Product Change Notification / SYST-26SSCP212

ERRATA - PIC18(L)F24/25K42 Silicon Errata and Data Sheet Clarification Document Revision

PIC18(L)F24/25K42 Silicon Errata and Data Sheet Clarification

Figure 44-5 Clock Timing

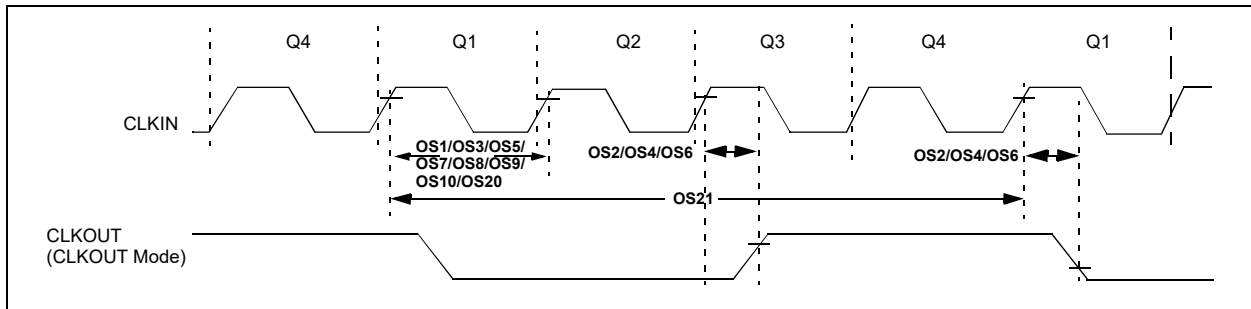
Figure 44-5 incorrectly shows the location of parameters OS1, OS2, OS3, OS4, OS5, OS6, OS7, OS8, OS9, OS10, OS20 and OS21. The correct location for the above-mentioned parameters is depicted in the following figure.
